### **DETAILED ACTION**

1. This office action is responsive to the preliminary amendment filed on 12/8/05. As directed by the amendment: claims 2-19 have been amended, no claims have been cancelled, and new claims 20 and 21 have been added. Thus, claims 1-21 are presently pending in this application.

8. Claims 1-3, 5-7 and 9-21 rejected under 35 U.S.C. 102(b) as being anticipated by Hackenbracht (U.S. Patent No. 5,405,009).

**Figure 1 (Hackenbracht)**

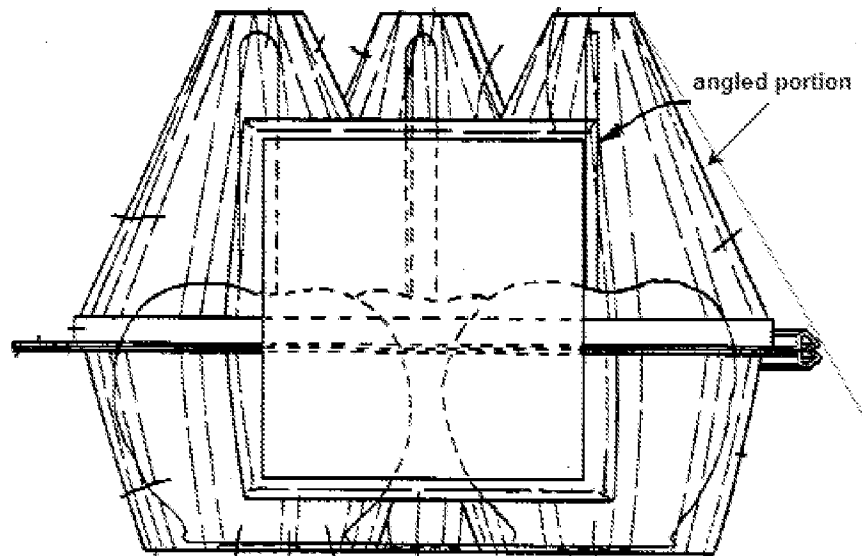
9. Regarding Claim 1, Hackenbracht discloses a container 10 (Figure 1) formed of plastics material (Column 6, Lines 40-41), the container having a recessed base 12 (Figure 1), with side walls 48 (Figure 1) along at least three sides of the recess (Figure 1); a domed lid 14 (Figure 1), the base and the lid being adapted for closure of the container around a joint surface 18 (Figure 1); a hinge 16 (Figure 1) connecting the lid to the base, the hinge being provided at the joint surface and at one side of the container and extending along a straight hinge region spaced out from the intersection of one of the side walls of the recess and the joint surface; the said one side wall having: a portion angled (Figure 1 below) at an acute angle with respect to the joint surface, the said wall portion being generally coplanar with the hinge region (Figure 1), whereby the container can be stood with the wall portion and the hinge on a support surface, with the intersection of the side wall of which it is a portion and joint surface set up from the support surface for collection of fluid from the contents of the container.

10. Regarding Claim 2, Hackenbracht discloses a recessed base which is formed with three sides intersecting the joint surface (Figure 1).
11. Regarding Claim 3, Hackenbracht discloses a recessed base which is formed with four sides intersecting the joint surface (Figure 1).
12. Regarding Claim 5, Hackenbracht discloses a container formed by thermoforming (Column 6, Lines 40-41).
13. Regarding Claim 6, Hackenbracht discloses a joint surface is provided with complementary formations 62 (Figure 6).
14. Regarding Claim 7, Hackenbracht discloses complementary formations which have a top hat shape 62 (Figure 6).
15. Regarding Claim 9, Hackenbracht discloses a hinge 16 (Figure 1) which is provided by an E section double channel, which has at least a straight hinge region (Figure 4).

16. Regarding Claim 10, Hackenbracht discloses a container 10 (Figure 1) which is shorter along the hinge region than in its dimension transverse to the hinge, whereby when stood on the angled portion of the base side wall, the container is generally stood on end, with the joint surface inclined backwards when the hinge is forwards (Figure 1).

17. Regarding Claim 11, Hackenbracht discloses a container 10 (Figure 1) which has a conventional bottom 86 (Figure 1) to the base recess, aside from the bottom function of the angled portion.

18. Regarding Claim 12, Hackenbracht discloses an angled portion which is parallel to the joint surface (Figure 1 above).

19. Regarding Claim 13, Hackenbracht discloses an angled portion (Figure 1 above) which is arranged to include the joint surface oppositely to when it is stood on end (Figure 1).

20. Regarding Claim 14, Hackenbracht discloses an inclined bottom which is substantially at right angles to the said angled portion (Figure 1).

21. Regarding Claim 15, Hackenbracht discloses a dome of the lid 14 (Figure 1) which is symmetrical in the lid.

22. Regarding Claim 16, Hackenbracht discloses a doming of the domed lid 14 (Figure 1) which is biased away from the hinge (Figure 1).

23. Regarding Claim 17, Hackenbracht discloses a container 10 (Figure 1) which is provided with ears 40/42 (Figure 1) in both of the lid and base material webs.

24. Regarding Claim 18, Hackenbracht discloses ears which have reinforcing formations 38 (Figure 1).

26. Regarding Claim 20, Hackenbracht discloses a hinge 16 (Figure 1) which is provided by an E section double channel, which provides a determined hinge axis (Figure 1).

27. Regarding Claim 21, Hackenbracht discloses a container 10 (Figure 1) which is provided with ears 40/42 (Figure 1) where one web is used, remote from the hinge (Figure 1).
